# SERVICE LETTER

**No.** 445

Piper Aircraft Corporation

**SUBJECT:** Installation of Nose Gear Drag Link Clevis Reinforcement Bracket

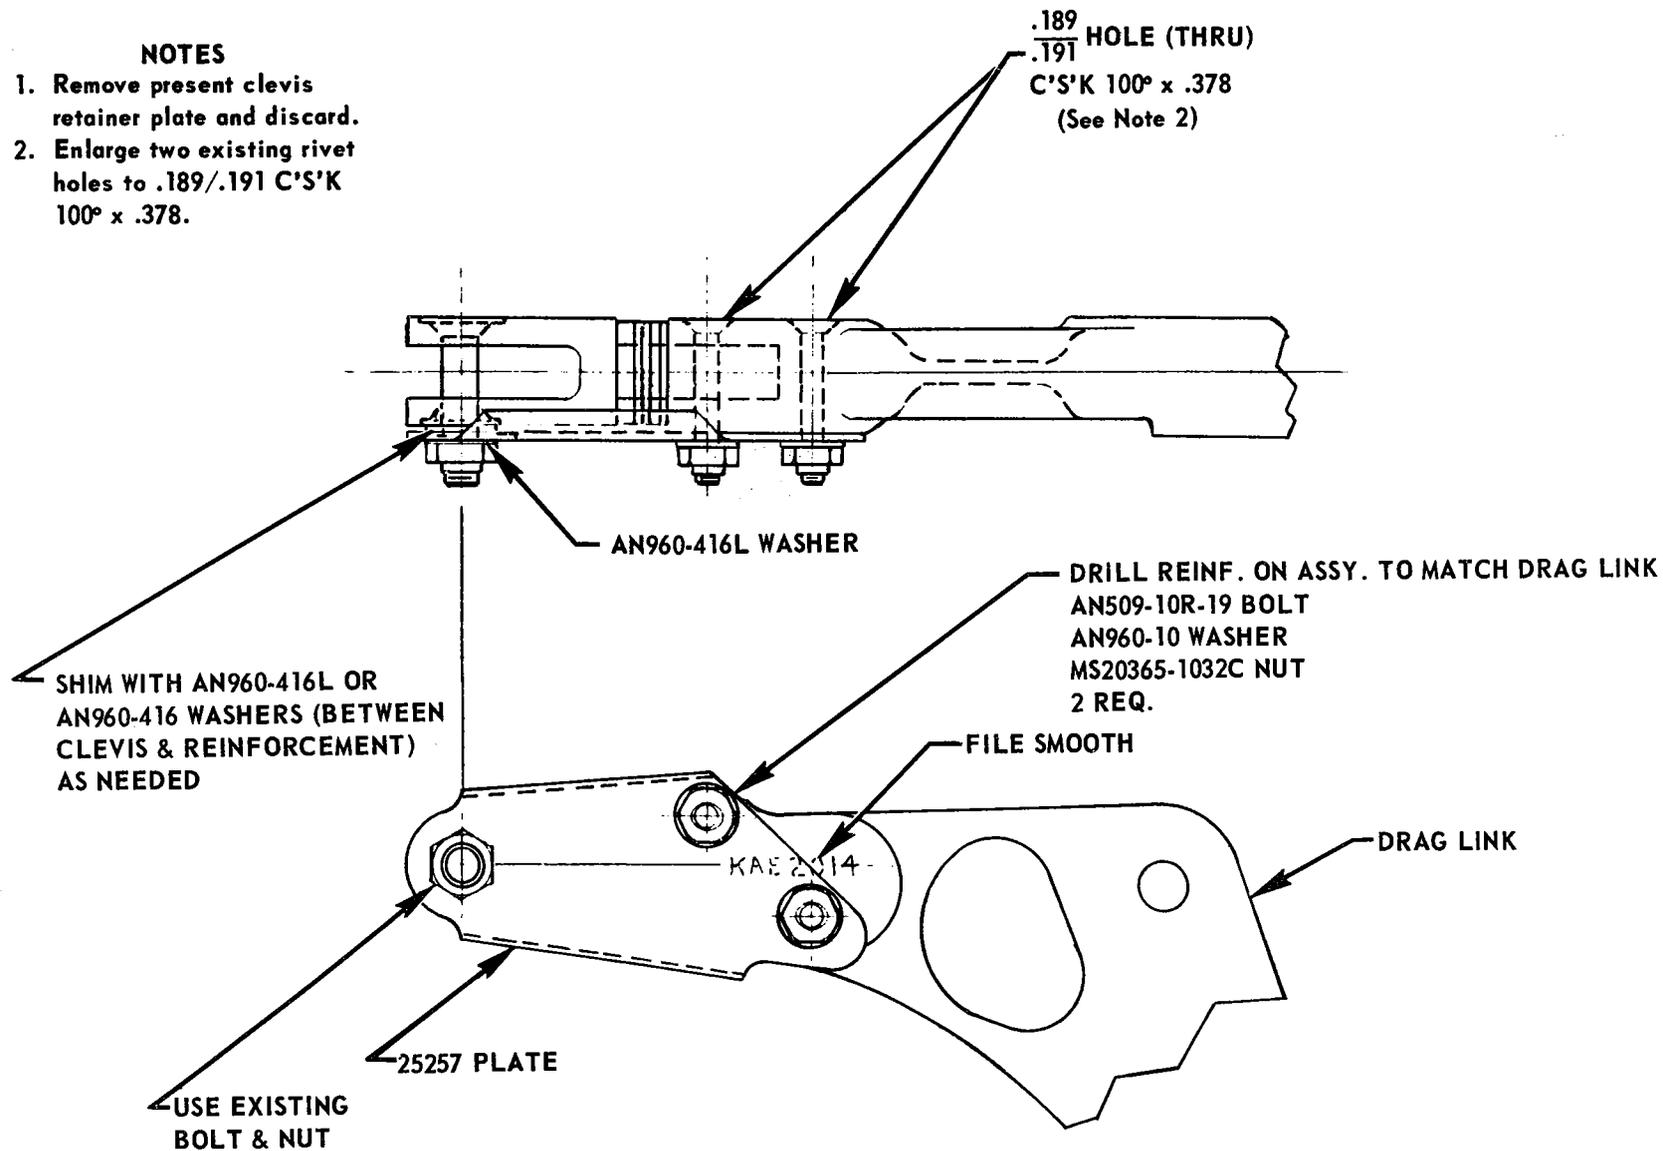
This Service Letter is to advise that Kit No. 756 911 consisting of a nose gear drag link clevis reinforcement bracket and necessary hardware is available for installation on the aircraft indicated by the above serial numbers.

It is requested that the reinforcement bracket, which is applicable to clevises, part numbers 20859-03 (HT), 20859-02, or 20859-00, be installed to derive the benefit of the additional support. See sketch on the reverse side of this Service Letter.

1. Remove present clevis retainer plate and discard.
2. Enlarge two existing rivet holes to  $.189/.191$  C'S'K  $100^\circ \times .378$ .
